Product Change Notice (PCN)

PCN Number: **PCN-0451162R-01**

Product(s) Affected: PJ-040CH

PREVIOUS CUI DEVICES DETAIL / IMAGE	NEW CUI DEVICES DETAIL / IMAGE

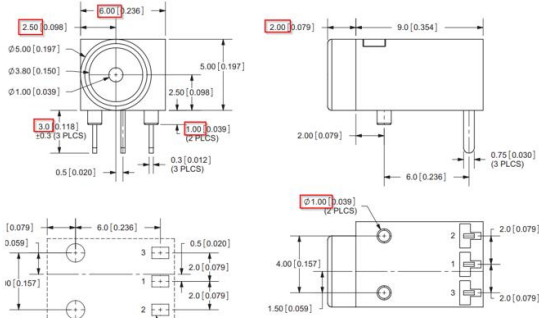
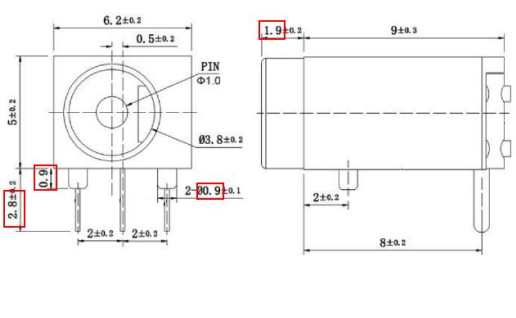
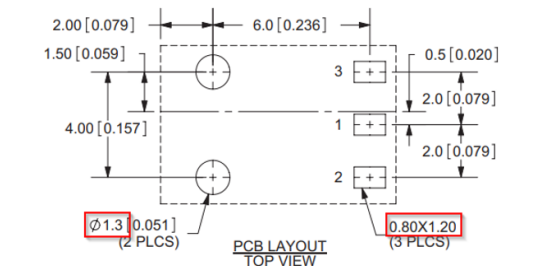
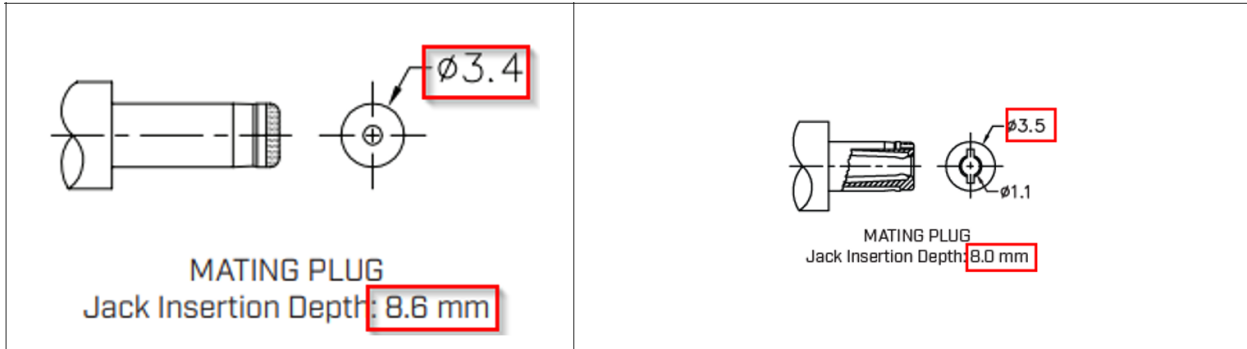
Description of Change: mechanical, material differences as shown below:

<p>PCB LAYOUT TOP VIEW</p>	 <p>Recommended PCB Layout Top View</p>																																							
<table border="1"> <thead> <tr> <th></th> <th>MATERIAL</th> <th>PLATING</th> </tr> </thead> <tbody> <tr> <td>center pin</td> <td>brass</td> <td>silver</td> </tr> <tr> <td>terminal 1</td> <td>brass</td> <td>silver</td> </tr> <tr> <td>terminal 2</td> <td>copper alloy</td> <td>silver</td> </tr> <tr> <td>terminal 3</td> <td>brass</td> <td>silver</td> </tr> <tr> <td>plastic</td> <td>PA66</td> <td></td> </tr> </tbody> </table>		MATERIAL	PLATING	center pin	brass	silver	terminal 1	brass	silver	terminal 2	copper alloy	silver	terminal 3	brass	silver	plastic	PA66		<table border="1"> <thead> <tr> <th>DESCRIPTION</th> <th>MATERIAL</th> <th>PLATING/COLOR</th> </tr> </thead> <tbody> <tr> <td>center pin</td> <td>brass</td> <td>silver</td> </tr> <tr> <td>terminal 1</td> <td>brass t=0.25</td> <td>silver</td> </tr> <tr> <td>terminal 2</td> <td>brass t=0.25</td> <td>silver</td> </tr> <tr> <td>terminal 3</td> <td>brass t=0.25</td> <td>silver</td> </tr> <tr> <td>cover</td> <td>PBT (UL94V-0)</td> <td>black</td> </tr> <tr> <td>housing</td> <td>PBT (UL94V-0)</td> <td>black</td> </tr> </tbody> </table>	DESCRIPTION	MATERIAL	PLATING/COLOR	center pin	brass	silver	terminal 1	brass t=0.25	silver	terminal 2	brass t=0.25	silver	terminal 3	brass t=0.25	silver	cover	PBT (UL94V-0)	black	housing	PBT (UL94V-0)	black

MATERIAL	PLATING																																						
center pin	brass	silver																																						
terminal 1	brass	silver																																						
terminal 2	copper alloy	silver																																						
terminal 3	brass	silver																																						
plastic	PA66																																							
DESCRIPTION	MATERIAL	PLATING/COLOR																																						
center pin	brass	silver																																						
terminal 1	brass t=0.25	silver																																						
terminal 2	brass t=0.25	silver																																						
terminal 3	brass t=0.25	silver																																						
cover	PBT (UL94V-0)	black																																						
housing	PBT (UL94V-0)	black
